PERMITTED DESIGN

PERMIT REVISION

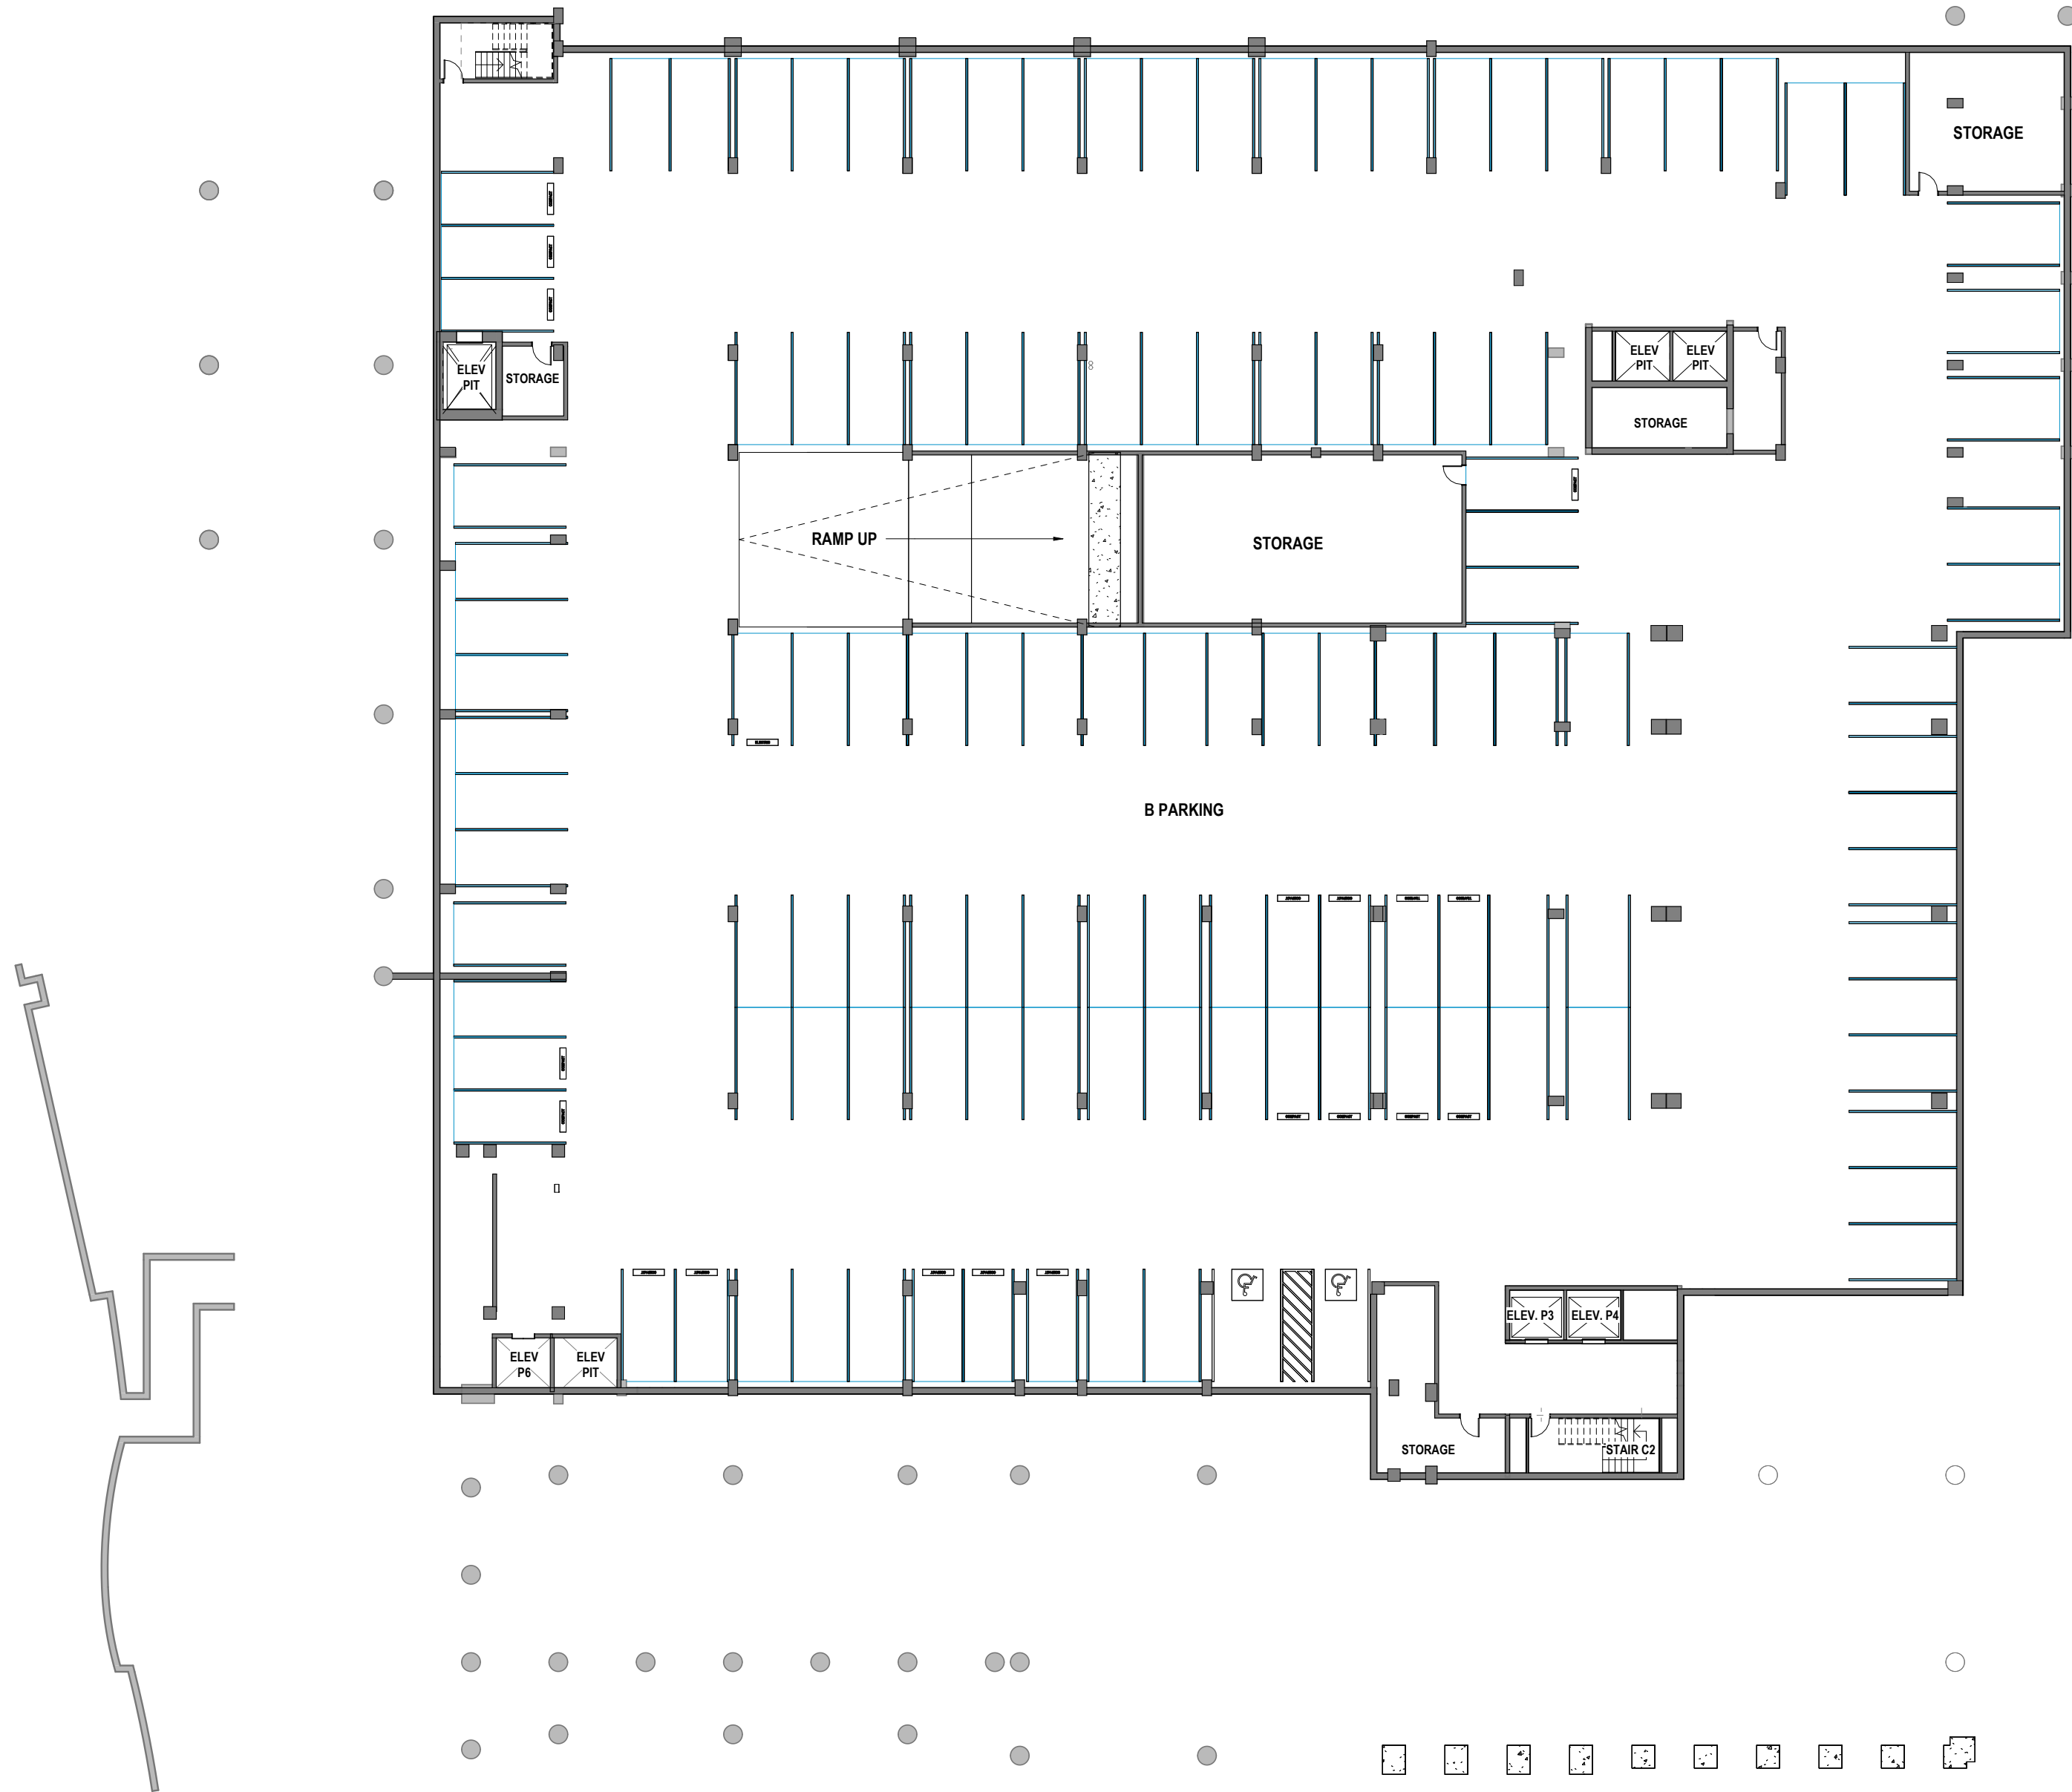
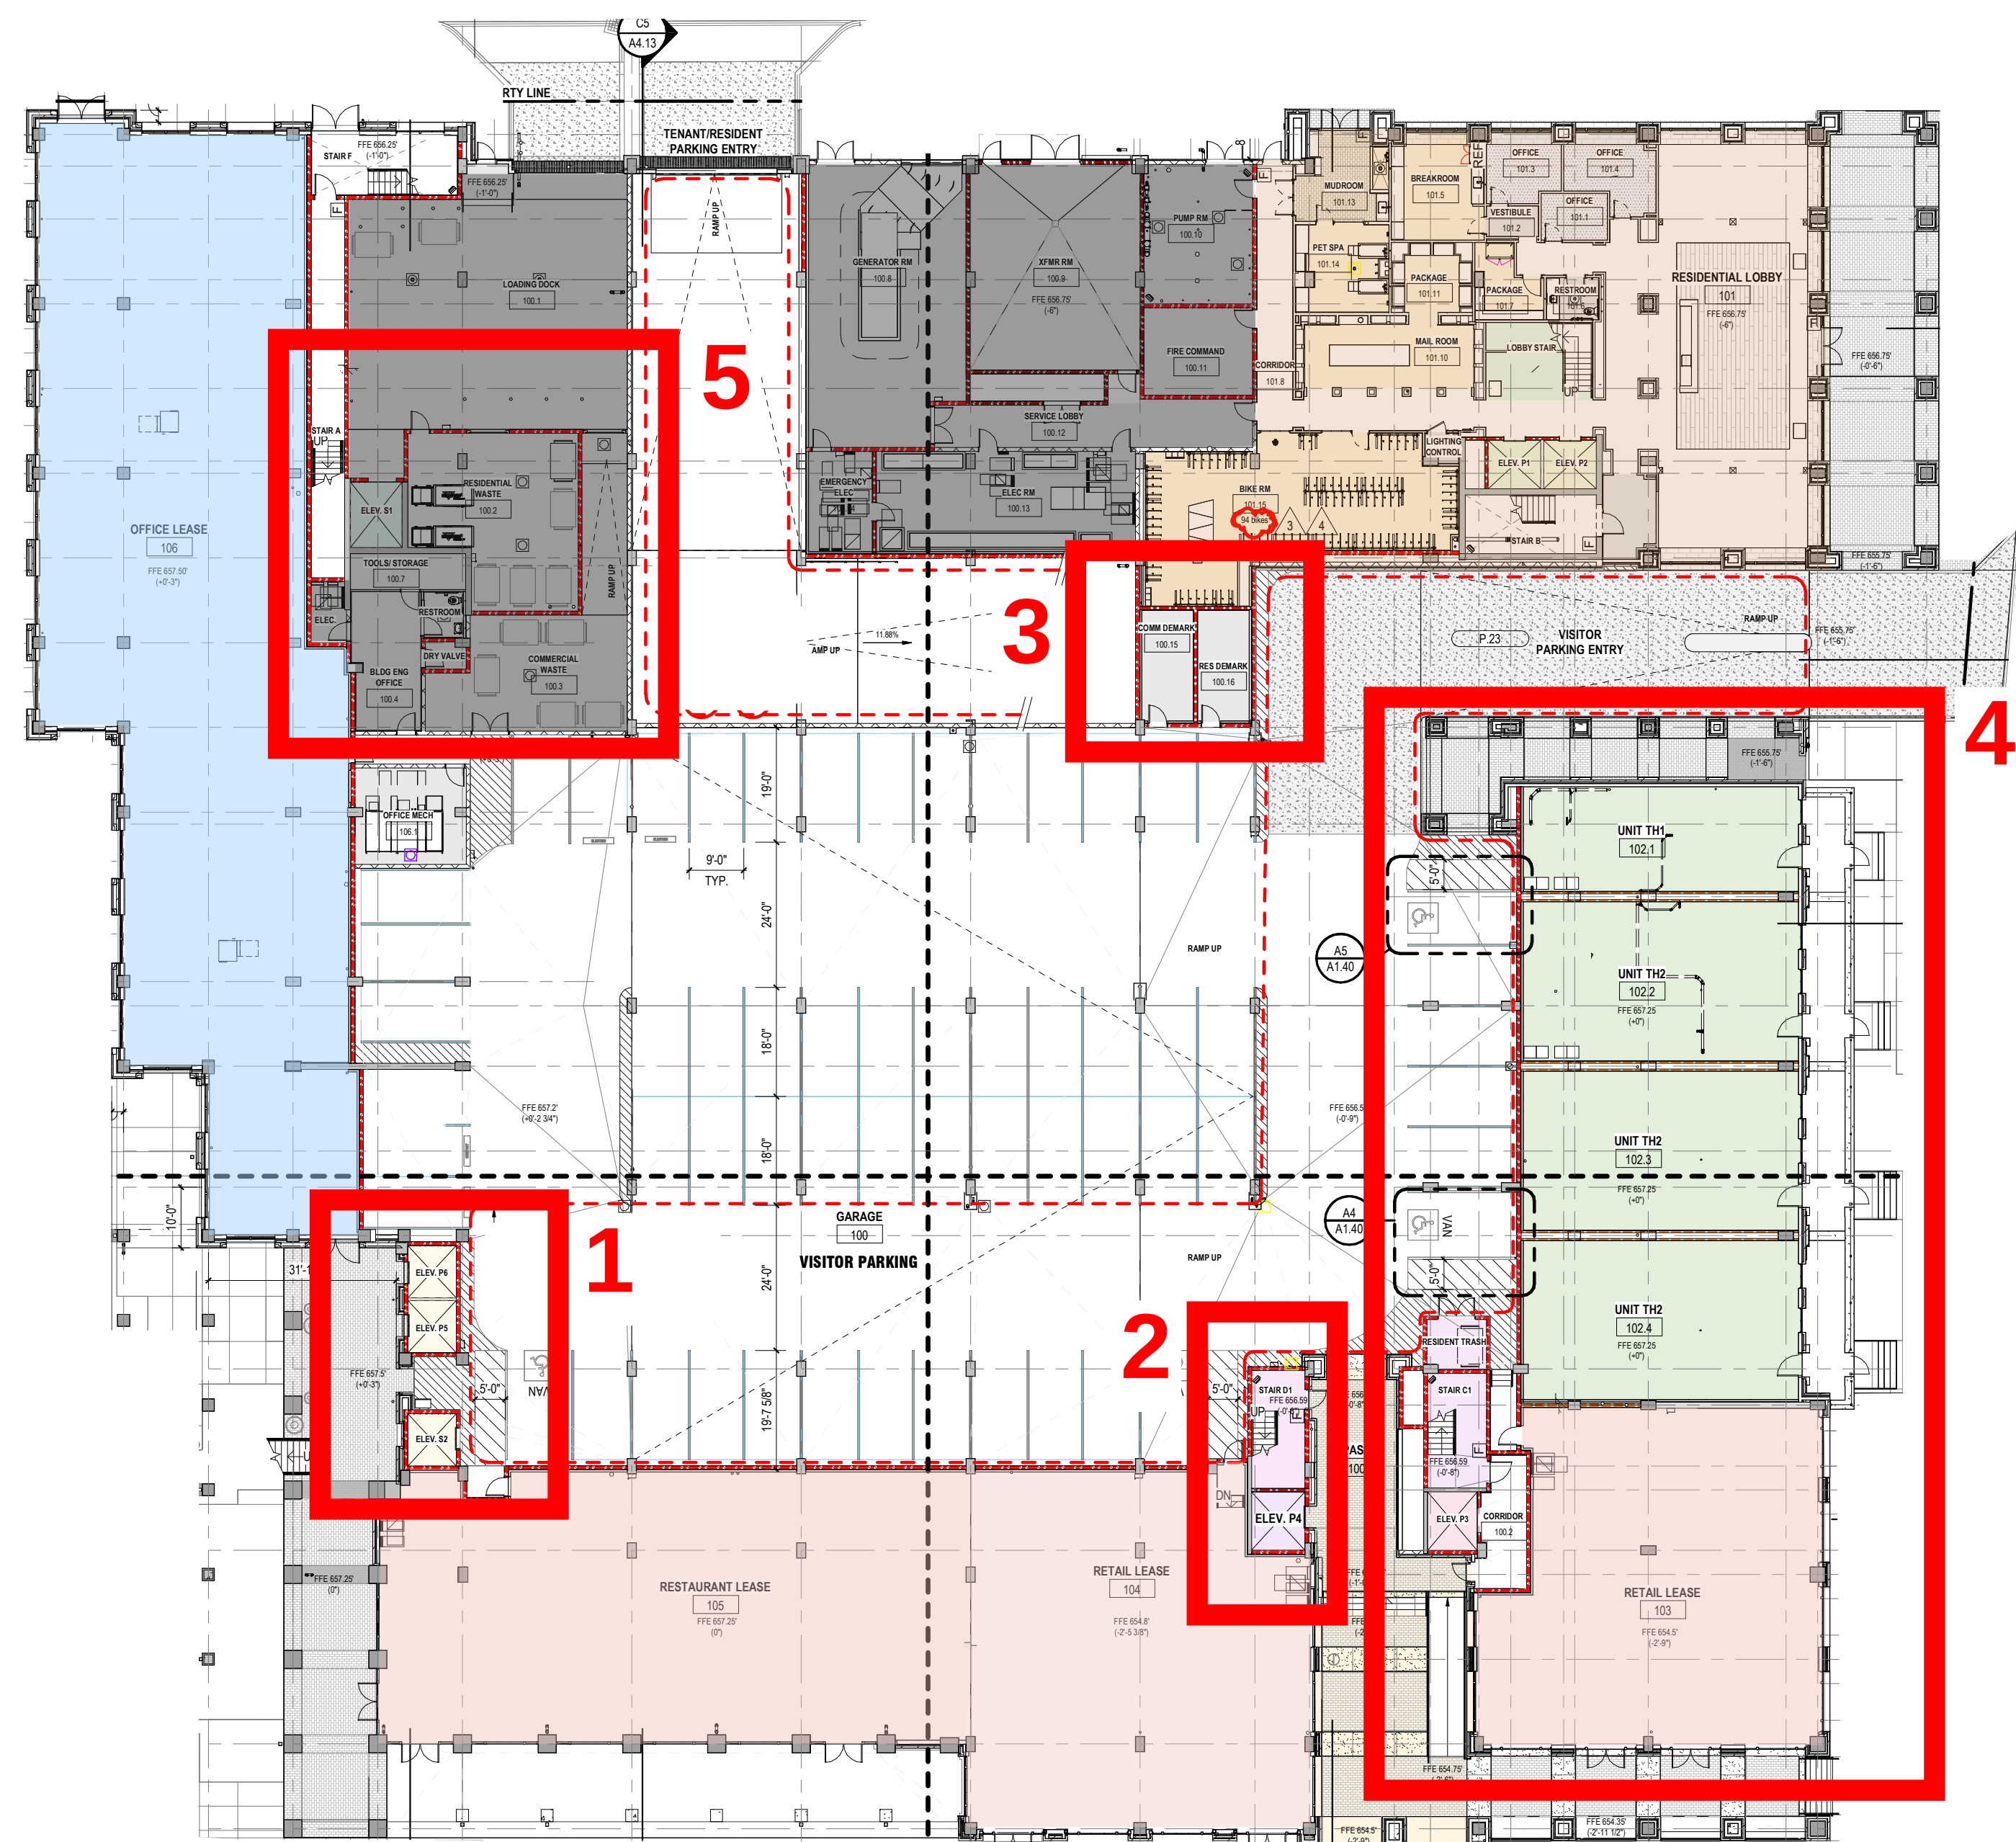
REVISIONS:

- 1. Added a basement level of parking.

GROUND FLOOR

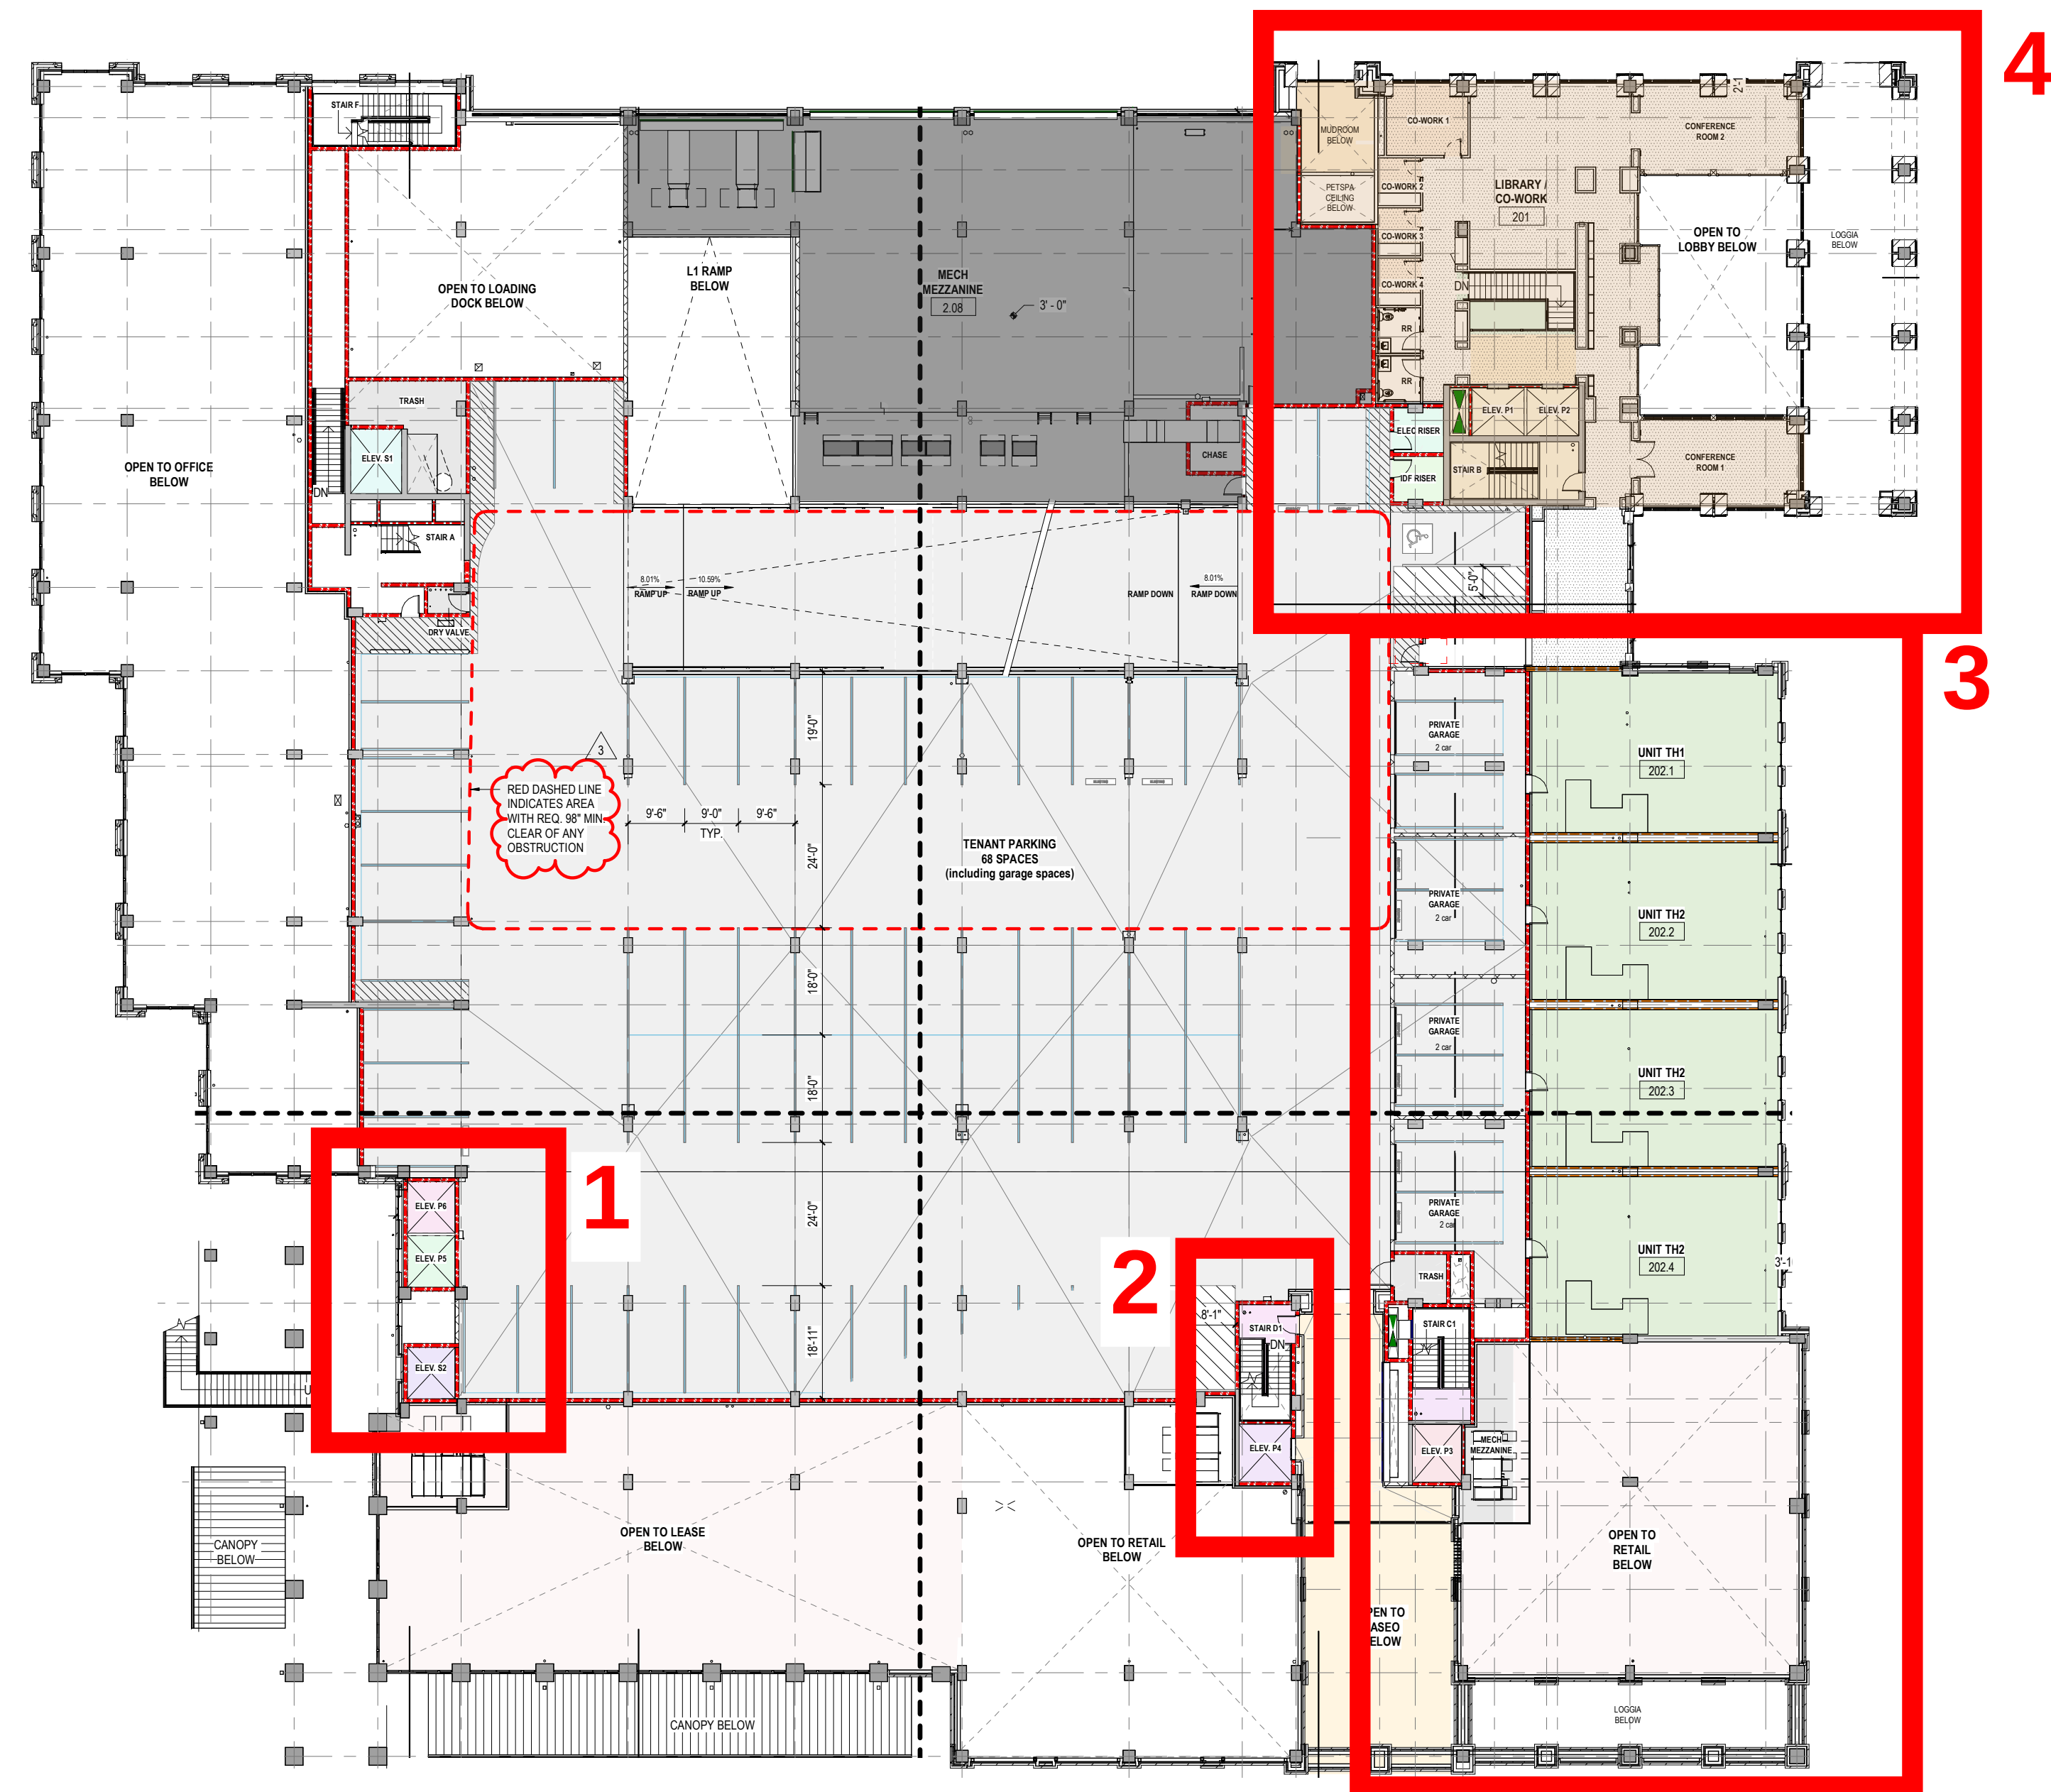
REVISIONS:

- 1. Reconfigured elevators. Removed (1) elevator.
- 2. Amenity level stair exit location moved. Removed (1) elevator.
- 3. Created ramp for basement parking.
- 4. Changed townhomes into retail. Changed retail into office lobby. Rearranged elevator and stair core to accommodate office building. Added an egress stair for office.
- 5. Rearranged trash rooms.
